DECISION OF THE PLANNING ADMINISTRATOR

**URBAN GROWTH AREA PRELIMINARY DECLARATION / SITE PLAN REVIEW /
ADJUSTMENT / DRIVEWAY APPROACH PERMIT CASE NO.: UGA-SPR-ADJ-
DAP18-02**

SUMMARY: An Urban Growth Area Preliminary Declaration to determine the public facilities required for development of 1.30 acres and a Site Plan Review, Class 2 Adjustment, and Driveway Approach Permit for a commercial office building for vehicle rental and a self-serve car wash located at 1950 22nd Street SE.

ENTERPRISE TRUCK RENTAL FACILITY

**SITE PLAN REVIEW /
 SITE DESIGN REVIEW
 SITE PLAN**

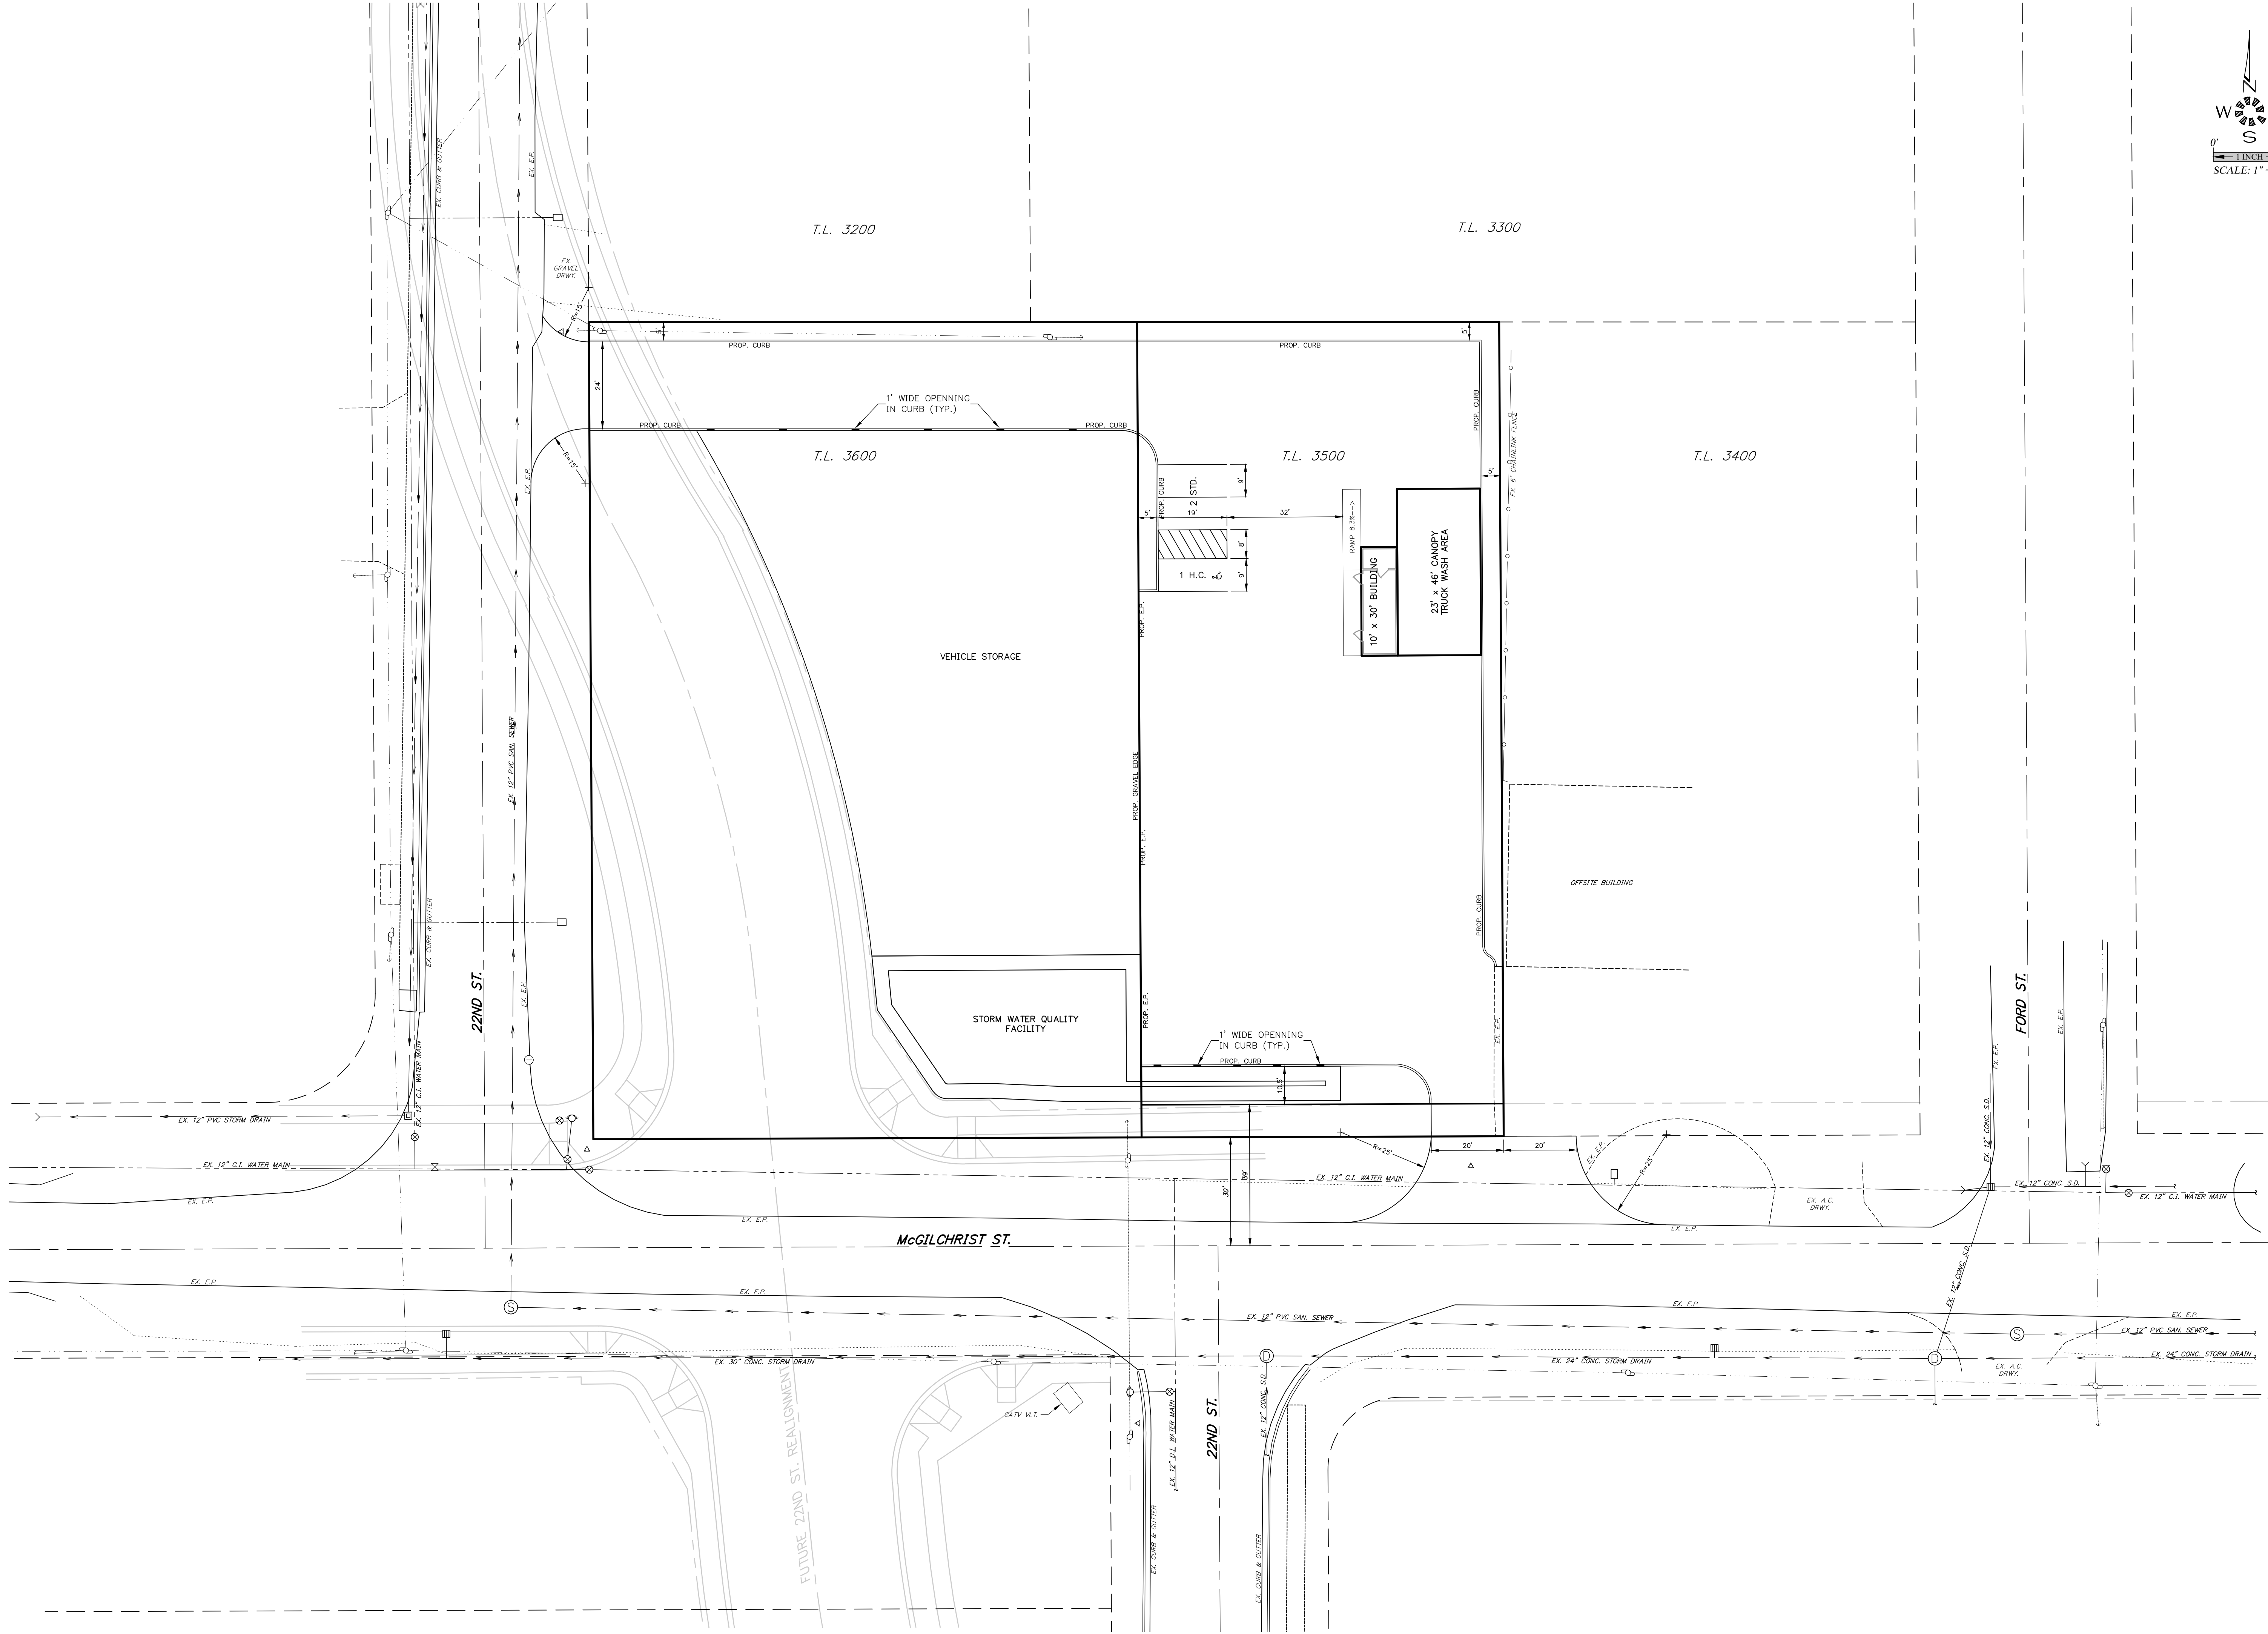
1. The application narrative indicates that the development includes a car wash and a commercial office building. The site plan shows a truck wash canopy, and a 10 x 30 "building". Is this the office building in question? Or is there another proposed?

2. The application narrative states that the proposed driveway on McGilchrist is 284 feet from the intersection. I assume this is referencing 22nd/McGilchrist. However, it is only about 145 feet from the intersection of Ford and McGilchrist. While this part of Ford does not currently go through to Judson, it remains a functional street passing through to Judson because of the configuration of parking lots between the northern end of Ford right-of-way and Judson.

3. If instead Ford is not being treated as a street and intersection, and it is instead viewed as a driveway, then the proposed driveway does not meet the minimum driveway spacing on McGilchrist.

4. A "temporary gravel parking lot" is noted on the site plan. My understanding is that such lots must truly be temporary--not just for short-term parking, but the parking use must be temporary. What is the timeline for a permanent parking lot that meets current stormwater code, and what enforcement mechanism will be in place to ensure that it is constructed? Why does the site plan not include the permanent parking lot?

Staff Response: The 10 x 13 building shown on the site plan is the office proposed, no other "buildings" are proposed at this time. It is our understanding the intention is for this to be a phased development. Any additional proposed development on the site will require a new site plan review. Staff will not know what else is proposed until the applicant submits another application for review in the future.

The applicant shows the realignment of 22nd Street SE on their plans. The realignment of 22nd Street SE encumbers the subject property. The proposed driveway to 22nd Street (collector) is approximately 250 feet from McGilchrist Street. The proposed shared driveway to McGilchrist Street SE (Arterial Street) is approximately 200 feet from the future signalized intersection with 22nd Street SE and approximately 150 feet from the intersection with Ford Street (measured center to center). The applicant has requested a Class 2 driveway permit and an adjustment to driveway spacing at the intersection of 22nd Street SE and McGilchrist Street SE. If an operational or safety issue arises from the location of the driveway near the future traffic signal, the City may require a raised median on McGilchrist Street SE to restrict the driveway to right-in/right-out. An adjustment to driveway

spacing is not required to Ford Street SE because the designation of this street is Local in the City of Salem TSP.

The applicant does show a parking lot meeting the standards of SRC Chapter 806 on Tax Lot 3500 near the area labeled as “temporary parking”. During the application completeness review, the applicant was notified that pursuant to SRC Chapter 806.035(g), off street parking and vehicle use areas shall be paved with hard surface material meeting the Public Works Design Standards (PWDS). The applicant was advised to revise their site plan to show a parking area meeting the standards, or apply for a Class 2 temporary use permit to allow seasonal or gravel parking. The applicant provided a revised site plan stating that the graveled area is vehicle storage and will not be used as a parking area. Pursuant to SRC 806.030(g)(1) paving is not required for vehicle storage areas within the IG zone.
